Town of Mammoth Lakes

Planning & Economic Development Commission Staff Report

AGENDA TITLE: Consideration of Use Permit 24-003, Major Design Review 24-006 and Adjustment 25-005 for a six-unit, multi-family residential apartment project subject to the Town's Density Bonus Ordinance located at 54 Mono Street. The project is categorically exempt from CEQA pursuant to CEQA Guidelines §15332, In-Fill Development Projects.

FIGURE 2 PROPOSED SITE PLAN

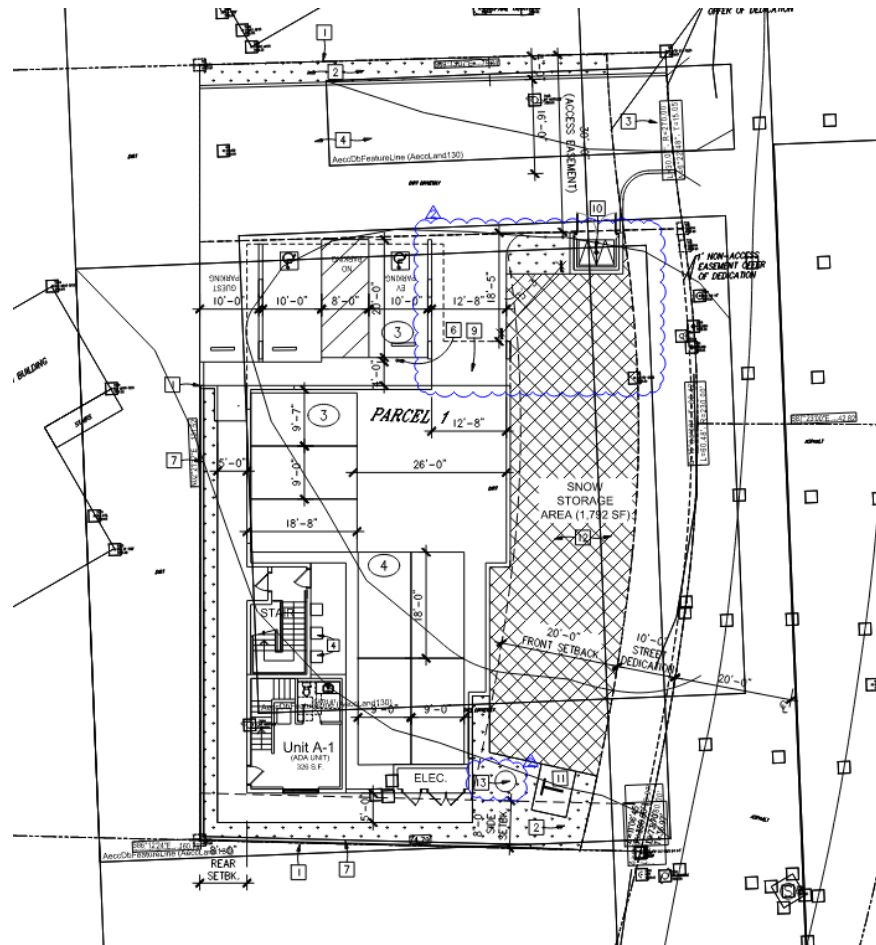
The site plan shown in **Figure 2** below illustrates the proposed site configuration and Staff's analysis of the project consistency with the Town Density Bonus Ordinance can be found under "Analysis of Key Issues" below.

The proposed parking configuration for the project consists of two tandem enclosed understructure spaces for each three-bedroom residential unit and one understructure space for each of the one-bedroom units. One exterior ADA parking space is located beneath the roof overhang adjacent to the building with an accessible route of travel to the ADA unit. A second ADA space is provided beneath to roof overhang and functions as a guest parking space. The third guest parking space is located on the exterior of the building but is not located under the roof overhang.

The proposed parking layout for the project meets the required amount of parking with approval of the concession requested to reduce the guest parking by one space. The proposed parking configuration ensures that the project will accommodate its share of parking needs on-site, which will avoid conflicts between vehicles and tenants with enclosed, assigned parking spaces. Since most of the parking is housed understructure, exterior parking is limited to three spaces and therefore the visual impact is minimized. The applicant has requested an Adjustment to allow for the single uncovered guest parking space to be located in the front setback.
